**AMENDMENTS TO THE DRAWINGS**

Application No.: 10/628,820

Appl. No. 10/628,820  
Amdt. Dated 26 Dec. 2004  
Reply To Office Action 29 Sept. 2004  
Annotated Sheet Showing Changes

Figure\_1

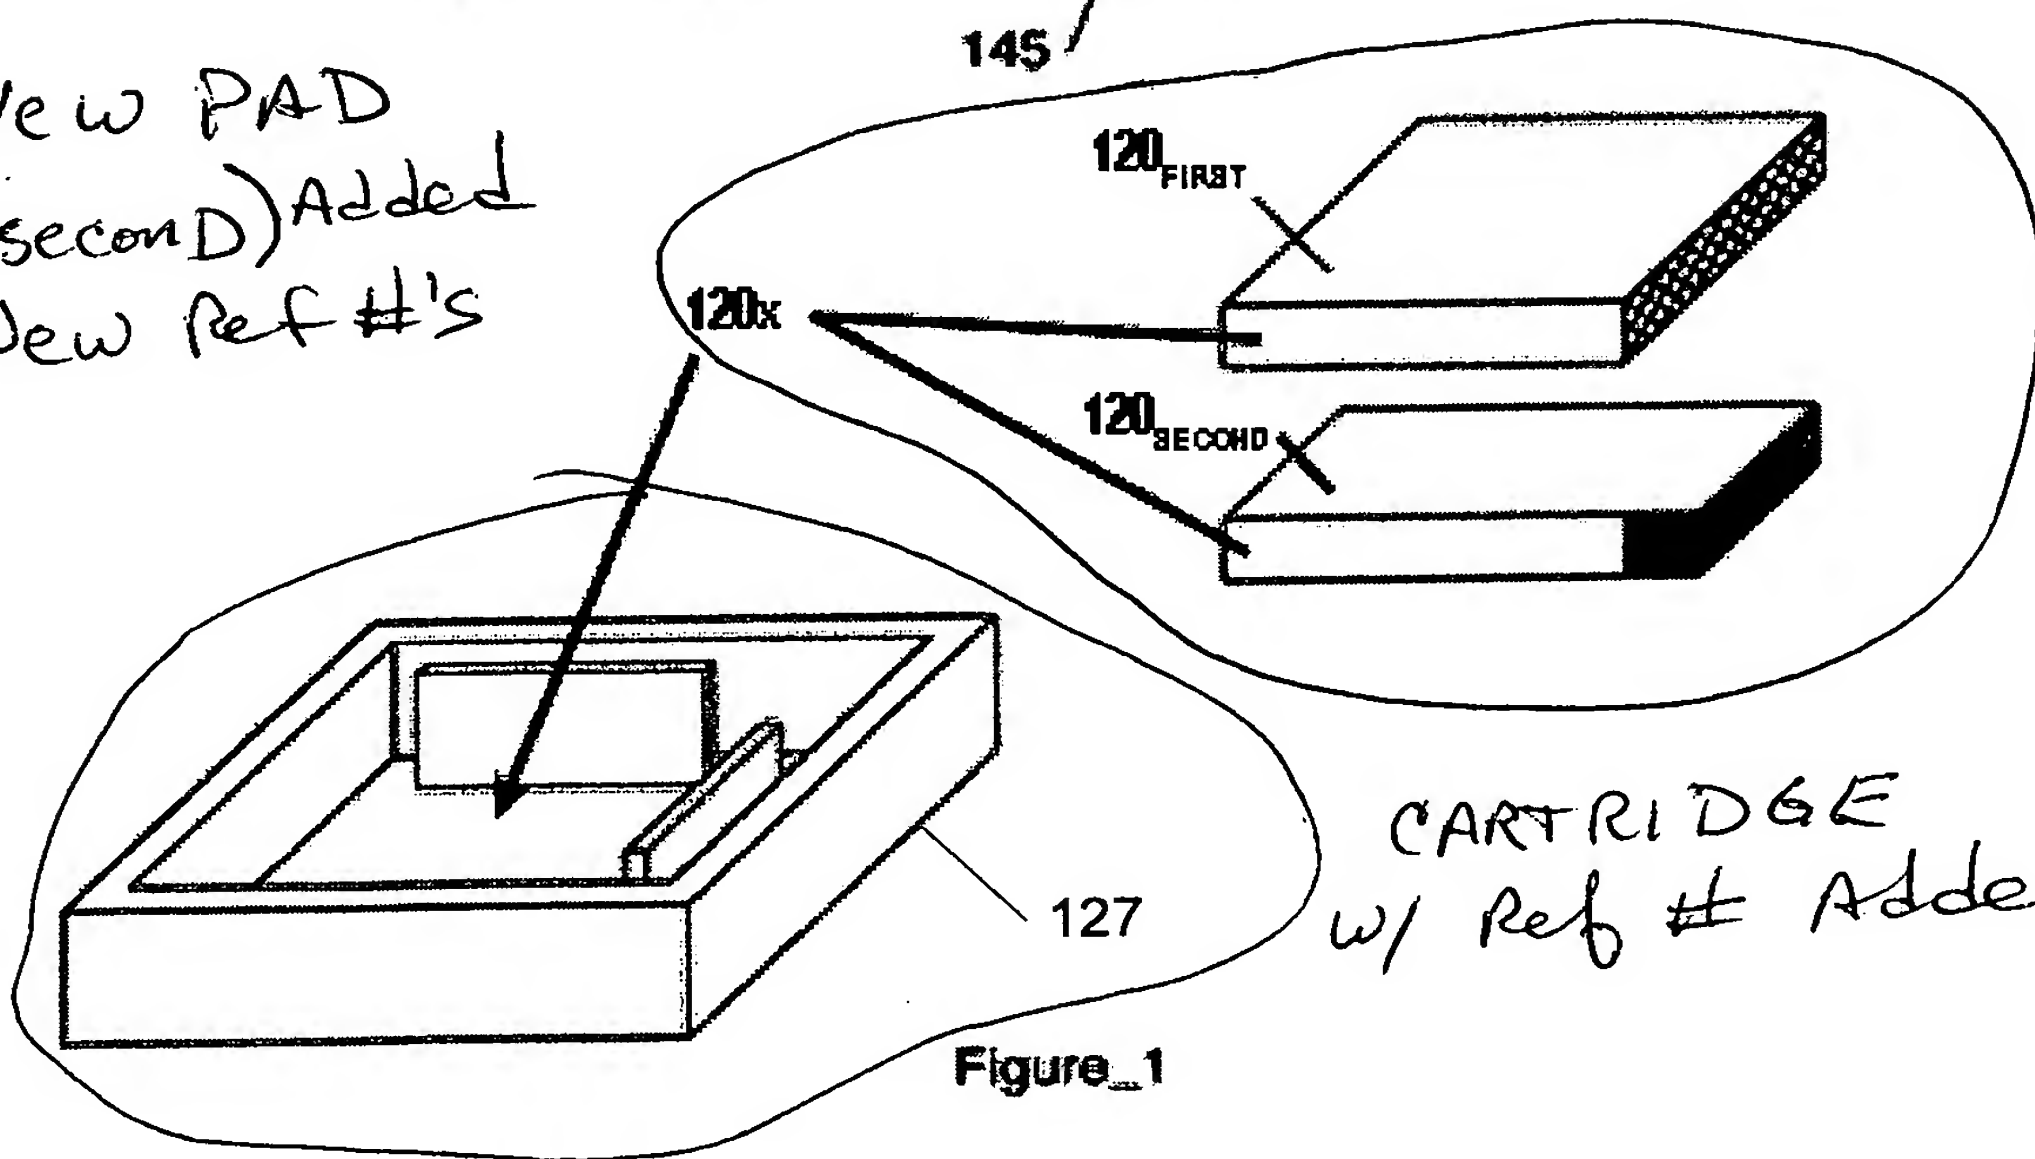
In Figure 1:

The disclosed adapter/cartridge was added and a reference (127) was also added.

The pad 120 originally depicted in Figure 1 has been replaced by a depiction of two-different pads as described in the specification. A first type (120<sub>FIRST</sub>) having adhesive along one side along one peripheral edge and a second type (120<sub>SECOND</sub>) having adhesive layered between successive pad elements. Additionally, these two pad types are shown having different peripheral dimensions as disclosed in the

specification. References to the pad numbers have been added, as well as an indication of the placement of either pad with respect to cartridge 127.

New PAD  
(120 second) Added  
& New Ref #'s

CARTRIDGE  
w/ Ref # Added

Amended Figure\_1 and Figure\_2 address the objections made to the originally submitted figures. Specifically, a number of specified claim elements were asserted as not being shown. The changes to Figure\_1 conforms it to the specification and originally filed claims and expressly shows the requested elements as well as other structural elements logically required for the proper understanding of the claimed invention. However, a change reflecting the assertedly missing identified claim 3 and claim 12 features has not been made and reconsideration of this objection is requested. Figure 1 depicts a generic image transfer engine that the specification identifies as encompassing many well-known types of devices, including laser printers (that use electrostatic transfer for example) and ink jet printers (that use ink ejection systems). Not all of these devices include apertures for image transfer so inclusion of a feature for

Figure\_2

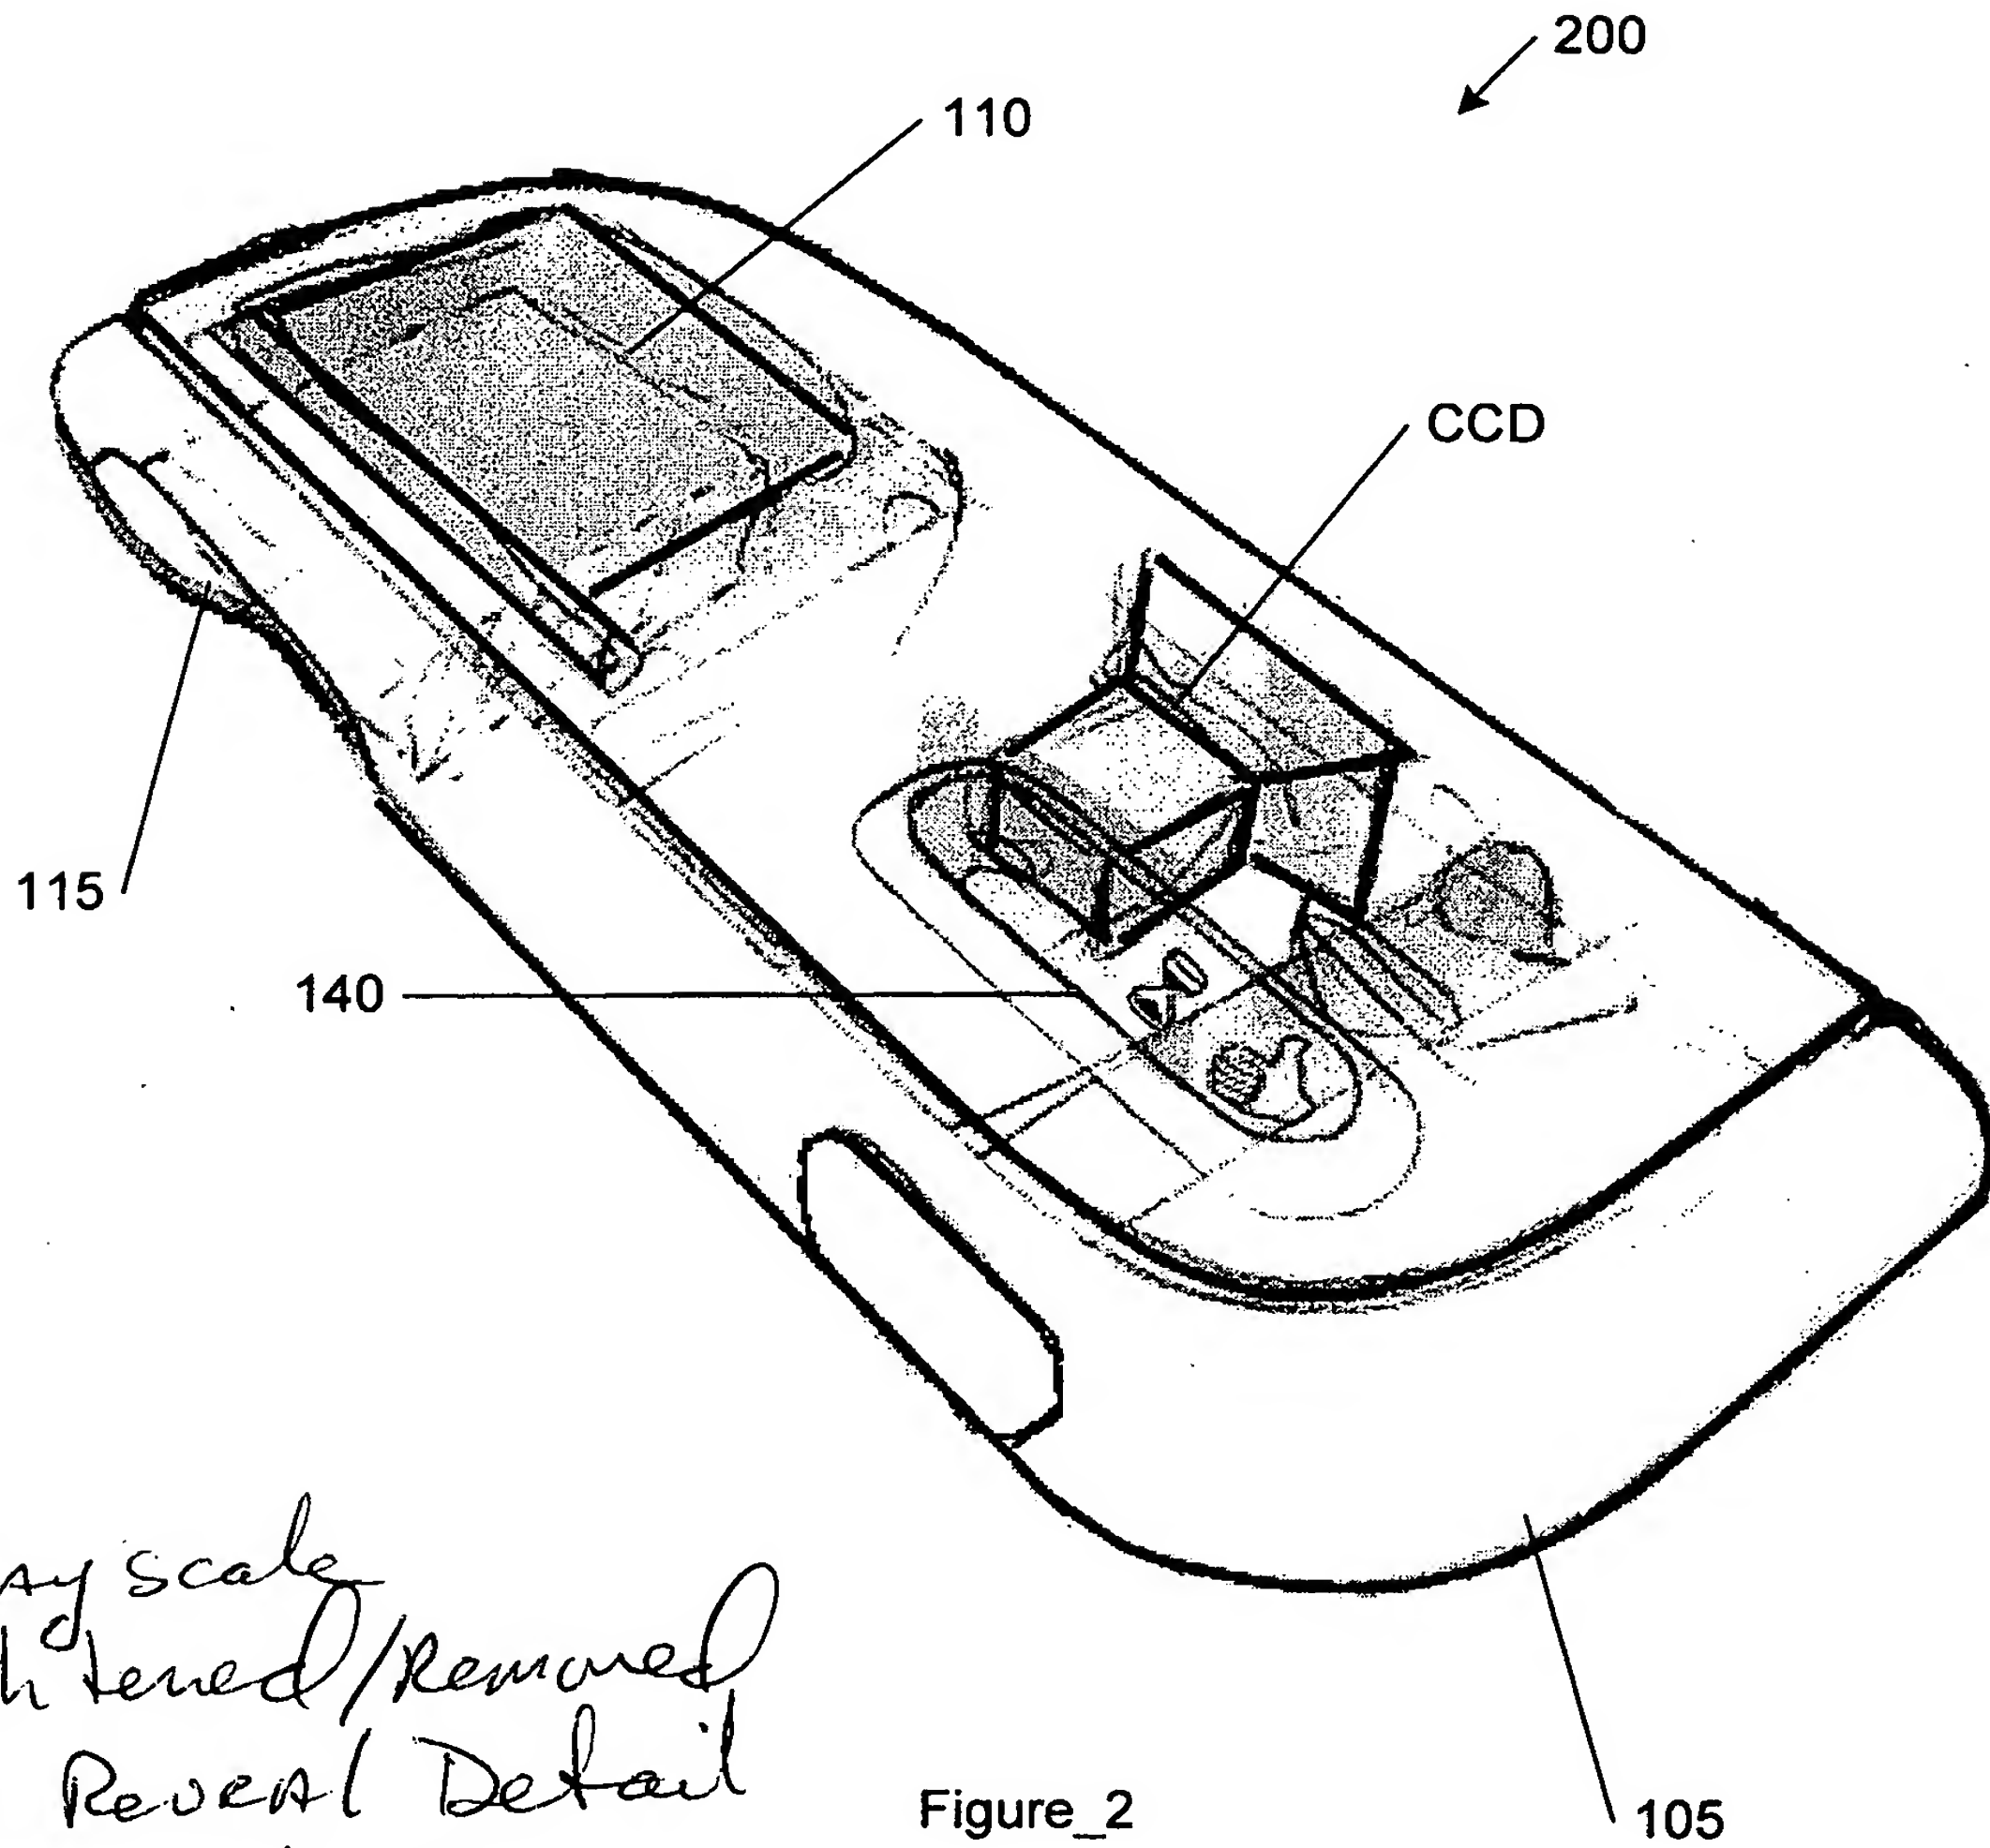
In Figure 2:

The Office Action asserted that due to various reproductions and processing the Figure\_2 was too dark to allow many details to be clearly seen. The undersigned reprocessed these figures and removed much of the grayscale to permit more details to remain through the processings and reproductions.

Gray scale  
lightened/removed  
to Reveal Detail  
& Some lines  
Added to sharpen  
existing features
